ADDENDUM NUMBER: **ONE**
April 14, 2010

BID NUMBER: **6838**

Park Improvement Plans for:

**Hunter Hobby Park Improvements
1401 Iowa Avenue, Riverside, CA**

**Bid No. 6838 - Addendum No. 1, Attachment I
 Partial Plan of DP-4, Demolition Plan**

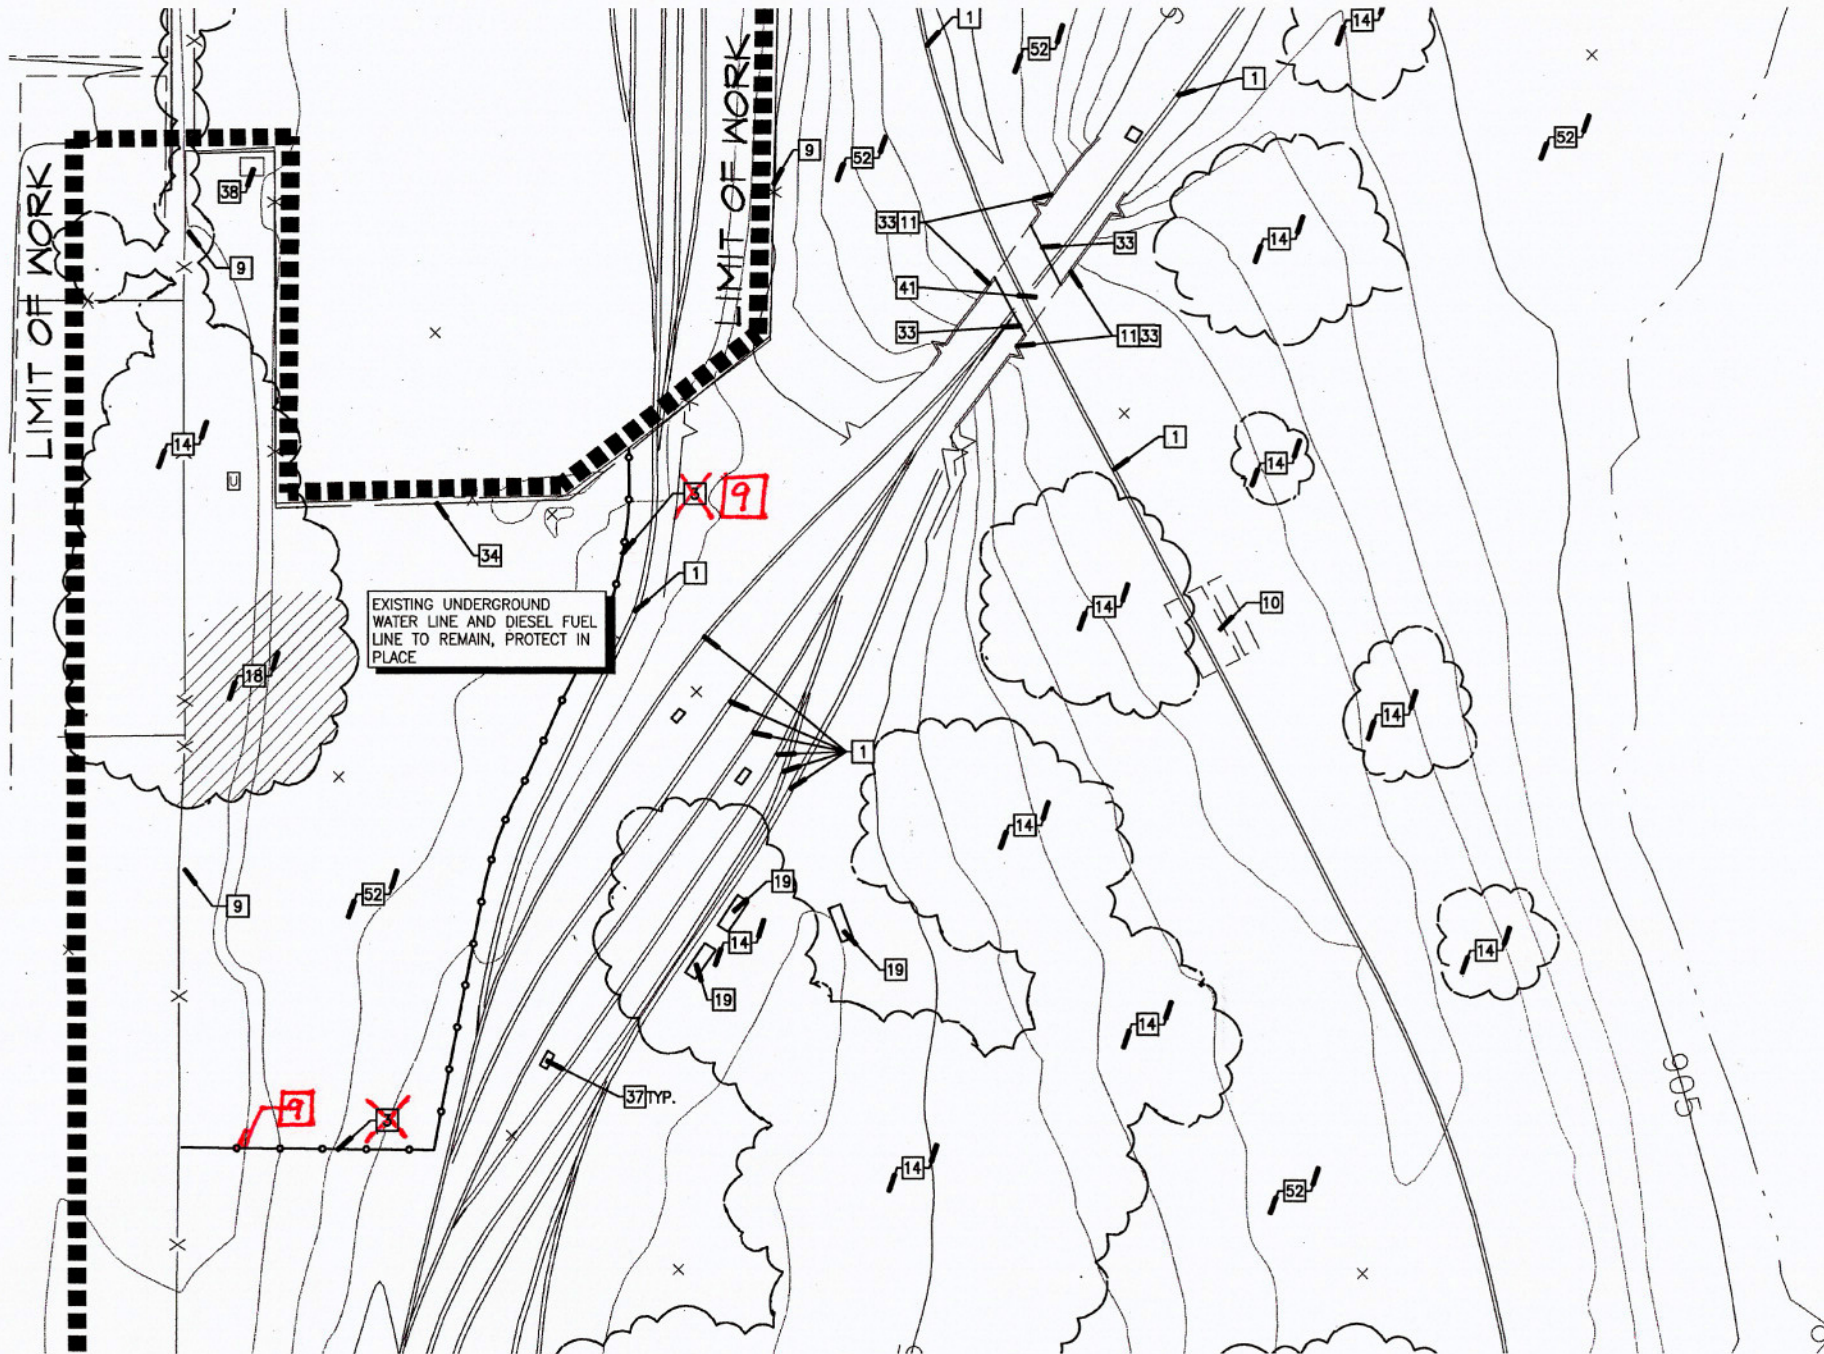
In lieu of removing the existing chain link fence south of the Riverside Live Steamer (RLS) Maintenance Yard as shown (Note #3), keep and protect the existing fence in place (change Note #3 to #9; see Attachment I).

- **At the revised staging area (see revised ALT-1 as Attachment III) for running miniature trains on the 2nd & 4th Sundays of the month during park construction, keep and protect the existing chain link fence (south of the RLS Yard) instead of removing the fence per Note #3 on DP-4 (see Attachment I).**
- **For the area inside the existing chain link fence (south of RLS Yard), omit the maintenance road with 7" aggregate base, new irrigation, and planting as shown on LC-4, LI-4 and PP-4 for this area. The area inside the RLS Yard's fence will be left open and used for parking.**
- **Disposal of excess soils off site shall be a part of contractor's responsibility and cost.**

ADD ALTERNATIVE PLAN
ALT-1
SHEET 14 OF 107

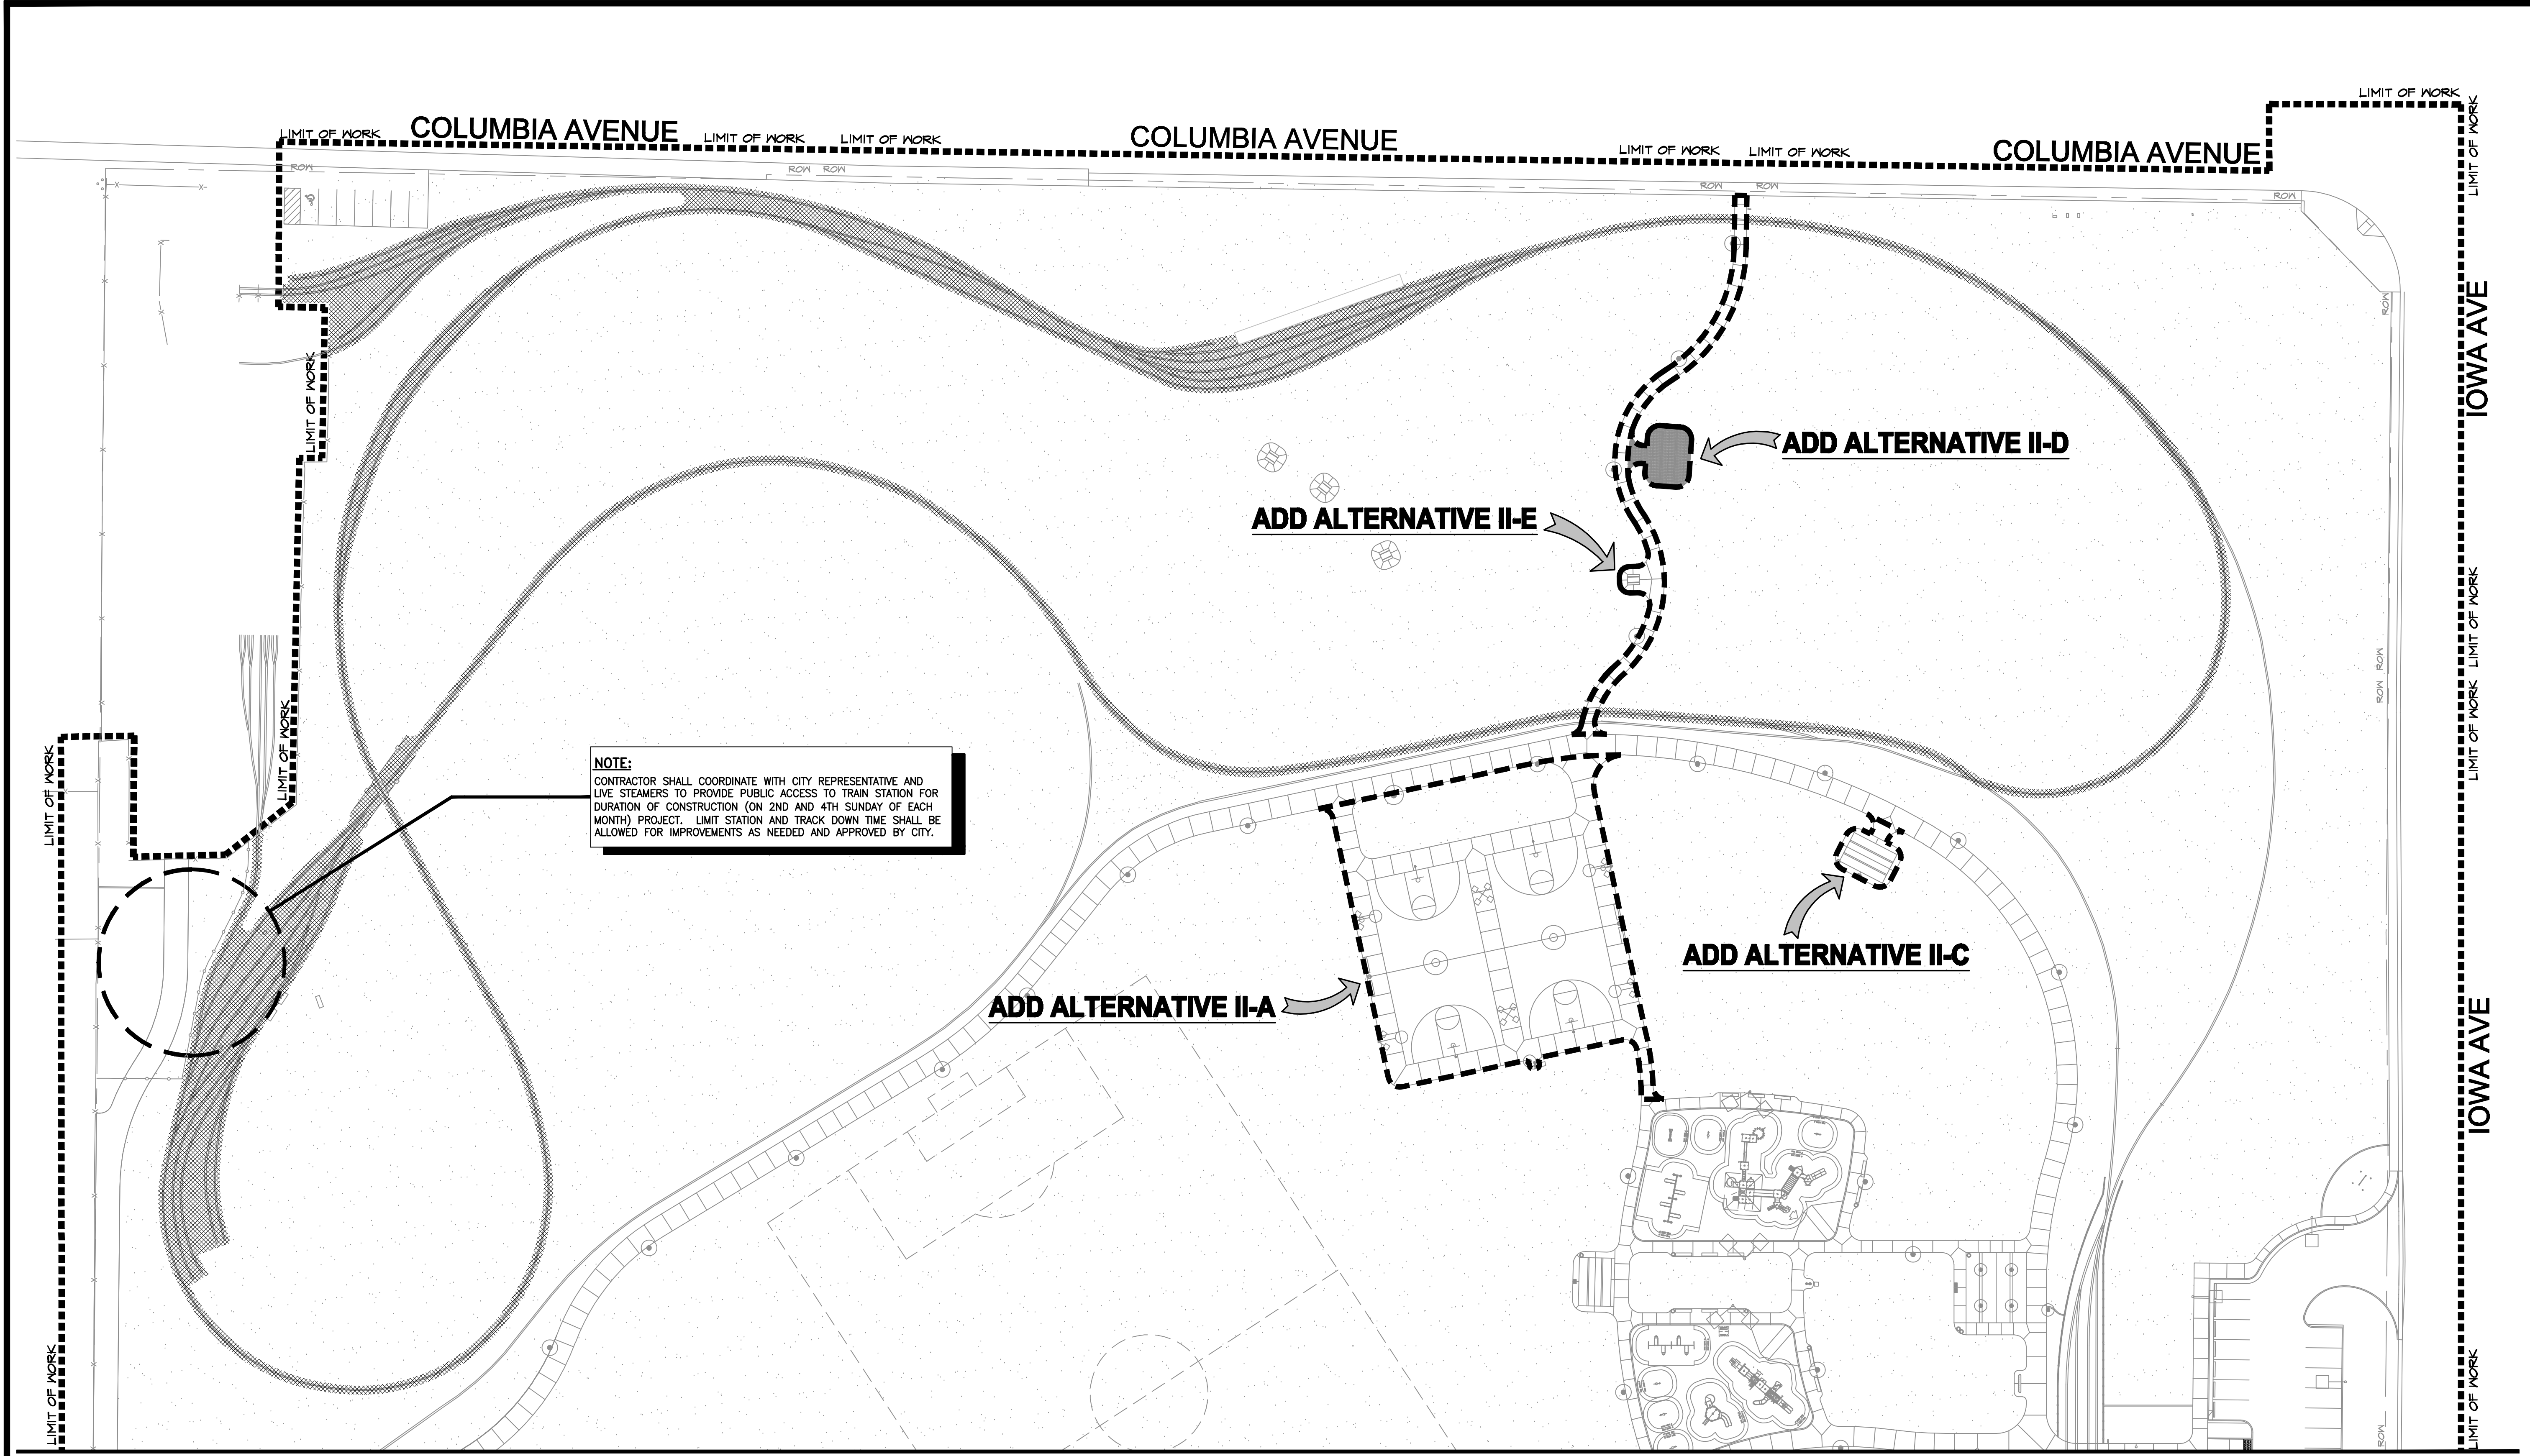
See the revised plan dated 4/8/10 for changed staging area (Attachment III).

Contractor is required to coordinate with the City's Parks Department and the Riverside Live Steamer (RLS) to allow public access to the old (temporary) miniature train station (near Columbia Avenue) northwest area of Park (south of the RLS Maintenance Yard) and the northern loop of track on the 2nd and 4th Sundays of each month during the construction period. See revised drawing ALT-1. The public may take access from the adjacent property's parking lot just west of Hunter Park to this area on those two Sundays. Limited down time (30 days maximum) for the old (temporary) train station and northern loop of miniature track shall be allowed for improvements as needed and approved by the City's Parks Department. The construction fence may need to be adjusted to allow such public access into the northern portion of the park and to separate the southern portion of park on the 2nd and 4th Sundays of the month.

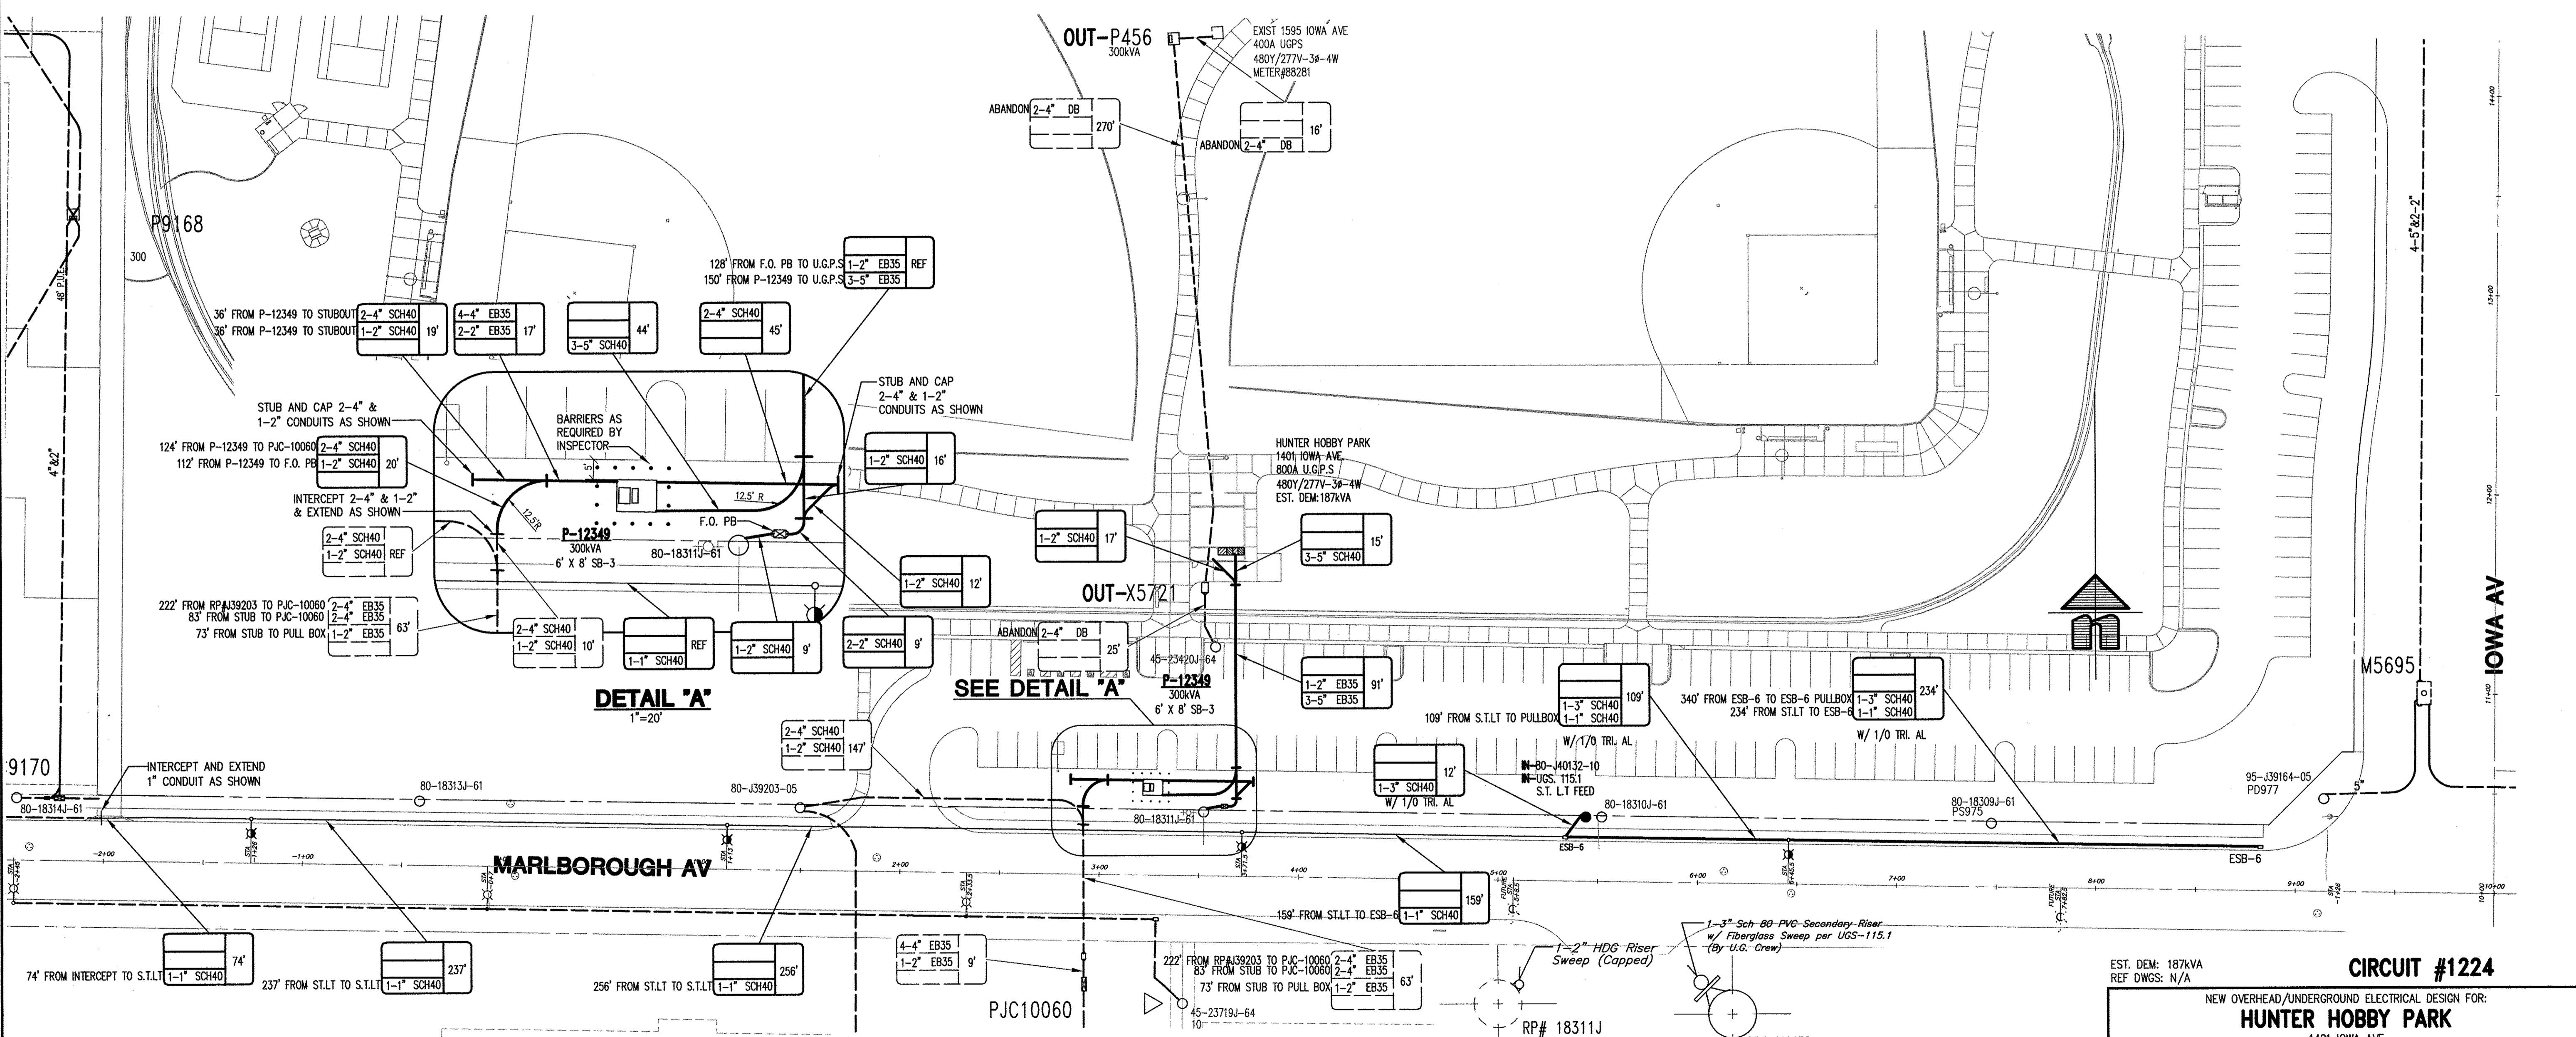
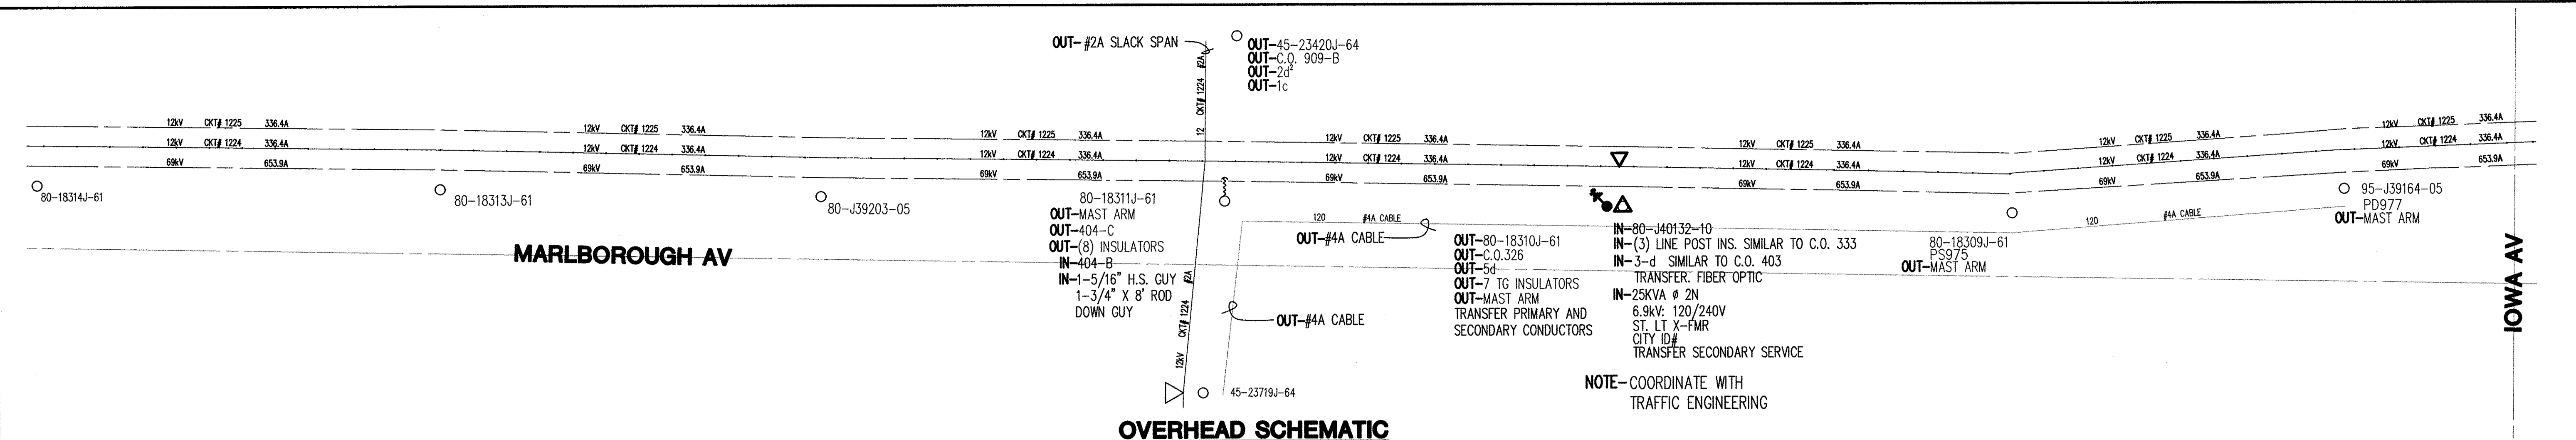
ITEM 30: Project Plans, Add Drawing No. 100003-29, Public Utilities' New Overhead/Underground Electrical Service Plan for Hunter Hobby Park to the Bid Set (see Attachment IV; 2 sheets):

These plans show the final transformer location, required conduits and pull boxes for providing electrical services to the site, Public Utilities Department's requirements, and street lights on Marlborough Avenue.

- New Note:** 1. Street light installation shall be included in the bid per City of Riverside Public Utilities' New Overhead/Underground Electrical Service Plans (#100003-29; see Attachment IV).
- 2. Contractor shall include in the bid to coordinate with City forces or others for water construction work, such as relocation / removal of fire hydrant (performed by city forces), regarding the construction schedule.
